43 Cholmeley Crescent, London N6 5EX (Planning Application Ref. HGY/2024/0715)

I am writing to object to the application for a Certificate of lawfulness for the erection of a single storey outbuilding (yoga room and gym) in the rear garden of number 43 Cholmeley Crescent.

Figure 3: Ground floor plan showing the proximity of the proposed garden room to the fence with 12 Kingsley Place

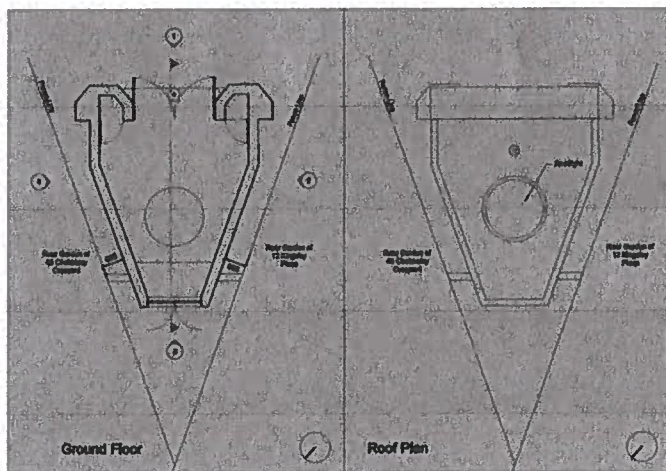
The proposed garden room will be approximately 0.66m from my garden boundary at the rear of the building; and approximately 0.8m from my boundary at the front of the building.

The garden room will be significantly larger than the existing garden shed. The dimensions of the existing garden shed are approximately 3m by 2m; whereas the proposed garden room is 6.7m deep and between 2 and 6 m wide. In addition, the proposed garden room has a height of 3 metres at the front and 2.5 metres at the rear, due to the slope of the garden. Elevation 4 on drawing no. 2247-400 Rev PD01 shows that approximately 80% of the building will have a height of 3 metres. The height of the eaves is therefore above 2.5 metres and the building will be 3 metres in height adjacent to my garden boundary.

Figure 4A – Section showing the level change across the site, and the height of the proposed studio (current application)

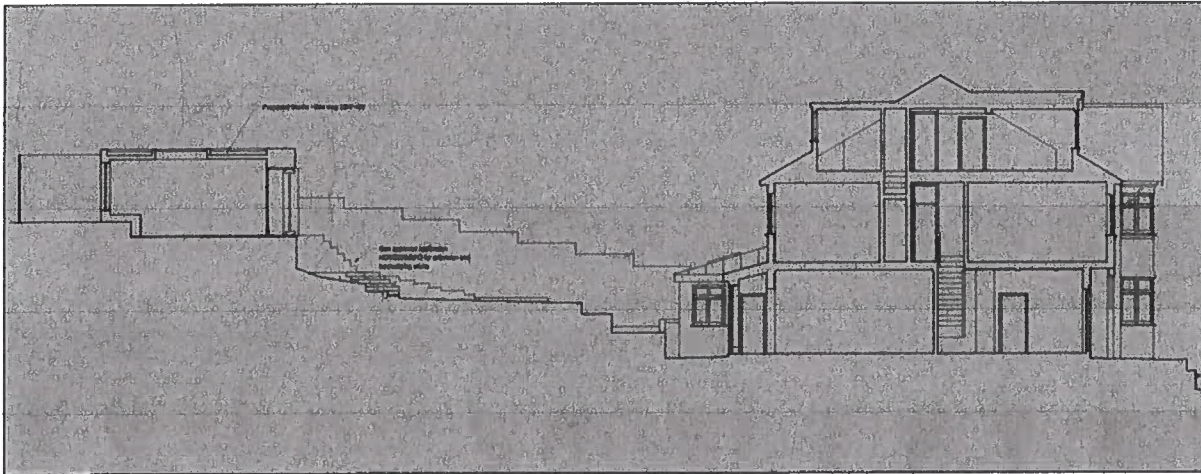
The proposed Section AA (drawing no. 2247-350 Rev PD01) clearly demonstrates the height of the top of the studio, which is the equivalent of two and a half storeys of the existing house, due to the ground level at this location (please see Figure 4A in the Appendix of this letter). Due to the site levels at the top of the garden, the studio will appear much taller than the elevations suggest and will be very visible from surrounding properties and the rear gardens of 12 and 13 Kingsley Place.

As detailed above, I consider that the current proposed garden room is too large and is sited too close to my property. As the rear garden slopes upwards towards my property, with a significant level change across the site, as shown on the submitted section the garden room will be visible from the properties and rear gardens of 12 and 13 Kingsley Place.

Figure 4B – Section showing the level change across the site, and the height of the proposed studio (refused application HGY/2023/1684)

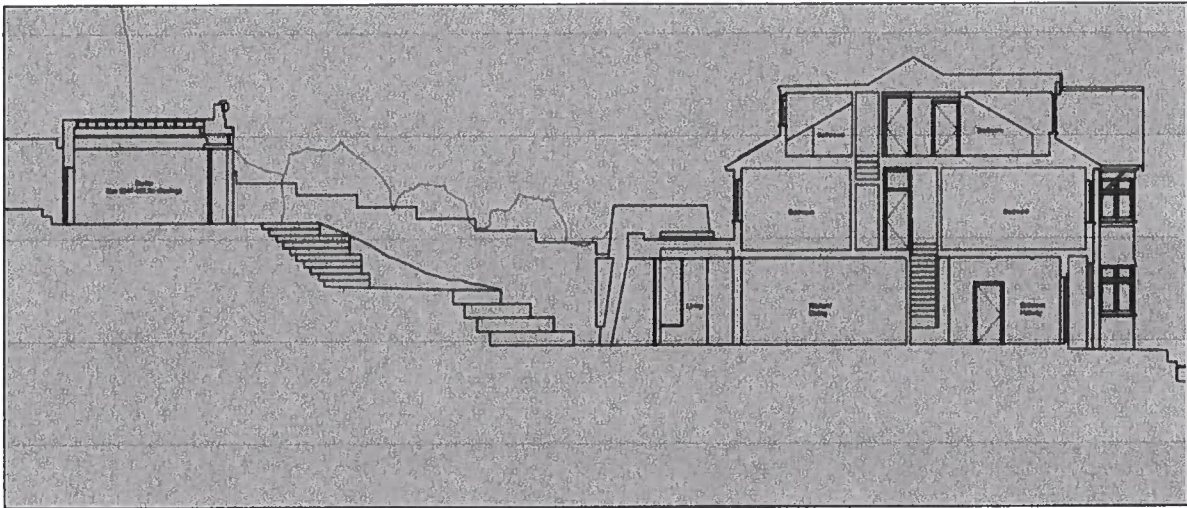
The dimensions of the garden building in refused scheme were 5.7m deep, between 2.8 and 5.5 m wide, with a height of 3.5m. The location of the previously proposed garden room was similar to that currently proposed.

The current proposal in comparison with the previously refused scheme would appear to be wider at its widest point (6 metres compared to 5.5 metres), deeper (6.7 metres compared to 5.7 metres), but slightly lower at 3 metres (compared to 3.5 metres).

Figure 5: Section through the building shows that the height of the building above ground varies from 2.5 m to 3m

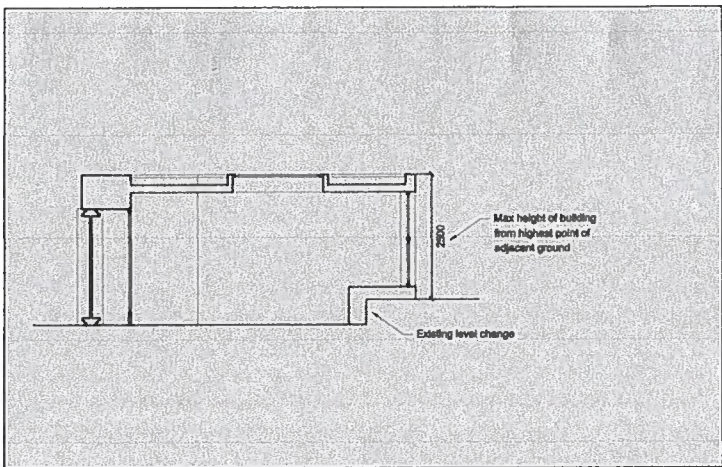
- Part (e) (ii), which does not allow buildings which would exceed 2.5 metres in height within 2 metres of the boundary of the curtilage of the dwelling house or (ii) 3 metres in any other case. The height of the building should be measured from the highest ground level immediately adjacent to the building to its highest point. If any part of the building, container or enclosure is within 2 metres of the boundary of the curtilage of the house, then the height limit for the total development is restricted to 2.5 metres if it is to be permitted development.
- Part (f), which restricts the height of the eaves of the building (i.e. where the lowest point of a roof slope or a flat roof meets the outside wall of the building) to 2.5 metres.

I would question therefore whether the proposal meets the requirements for permitted development, given its proximity to the site boundary. Moreover, given the sensitivity of the site within the Highgate Conservation Area and close to a TPO, I consider that the proposals should be fully assessed.

Figure 6: Siting of the proposed garden studio (refused application and current application)

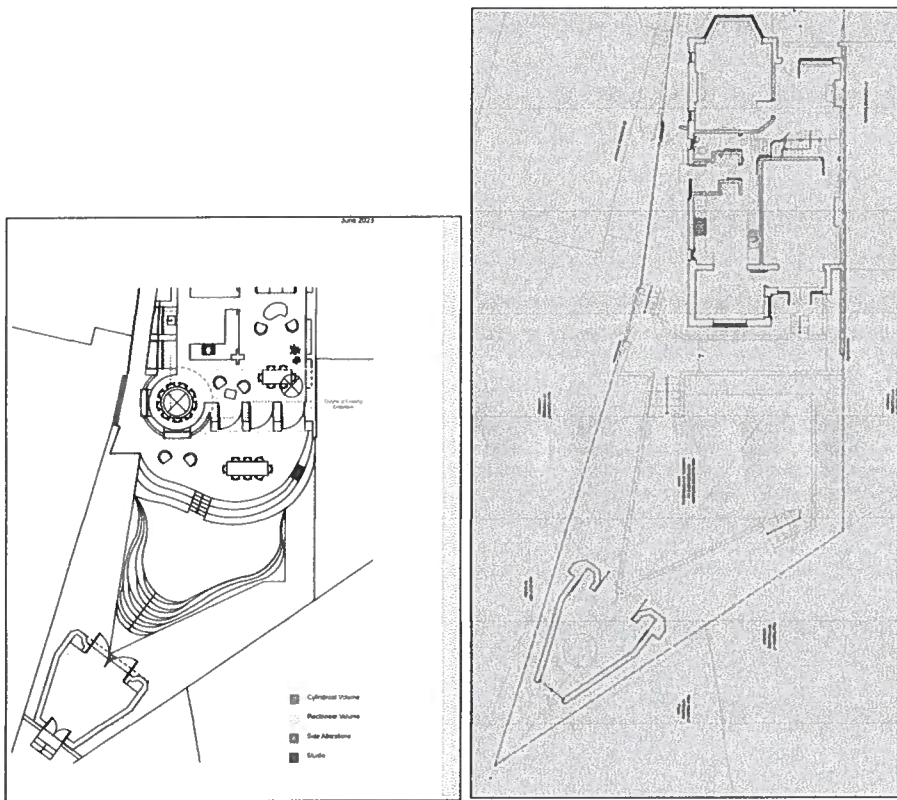
Paragraph 5.15 of the officers report also states that *"the combination of the large footprint, scale, height and the general elevated nature of the rear garden, mean the structure would be overly prominent and would be an incongruous feature in this rear garden setting. It would be highly visible sitting in stark visual contrast to other more traditional garden buildings with the eye unacceptably being drawn to it from the rear facing windows and rear gardens of neighbouring properties. This would be particularly so in the winter months when levels of greenery in some of the closest gardens would be reduced."* As noted above, the footprint of the proposed garden room is both wider and deeper than the previously refused garden room.

Figure 7: Extract from previously submitted Tree Survey, demonstrating the extent of the RPA and Canopy of existing trees (application ref. HGY/2023/1684)

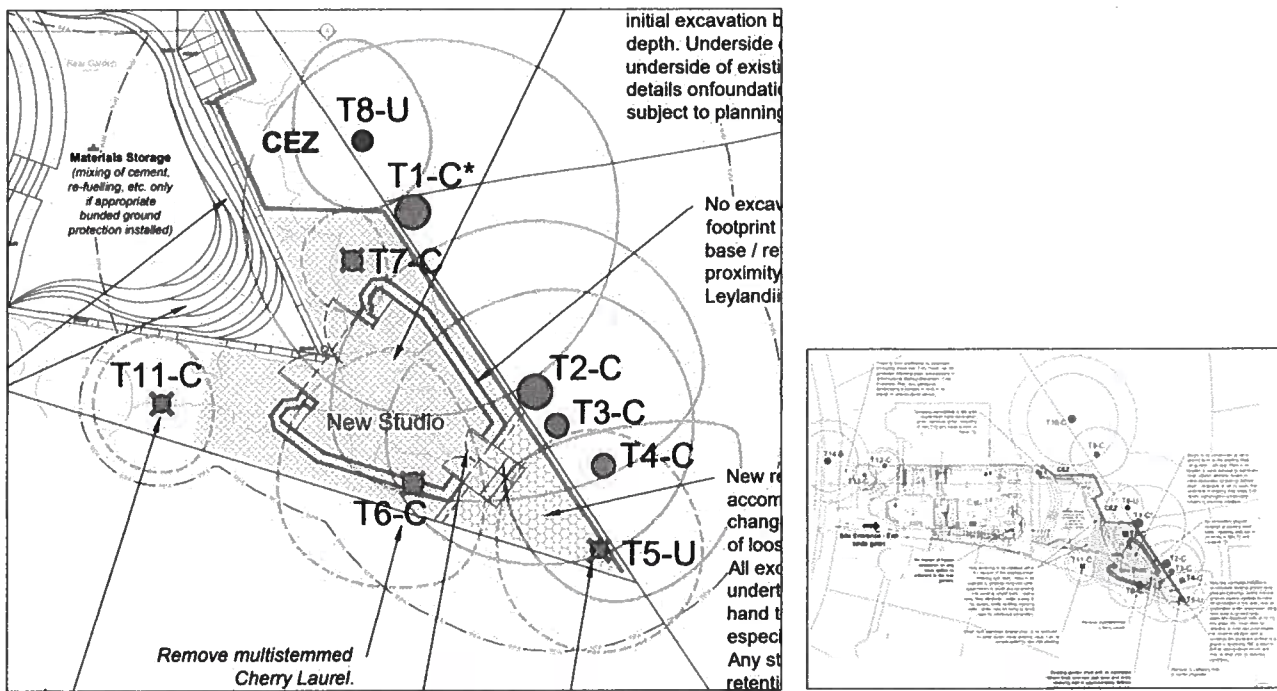
I also have serious concerns that the proximity of the proposal to the site boundary and the mature trees along the boundary will impact on the existing protected TPO trees and their RPA. Moreover, the proposed works could not be carried out without damage to these protected trees.

Whilst a Tree Survey, Arboricultural Impact Assessment and Arboricultural Method Statement were submitted with the previous planning application, no information is provided with the current Certificate for Lawful Use. As the tree survey was carried out on 20 April 2023, it is still considered

relevant. As the siting of the new proposal is similar to that of the refused scheme, there would be an impact on the RPA of any individual retained tree (this was previously estimated to be up to 20%). Similarly, construction works could damage the roots of these trees.
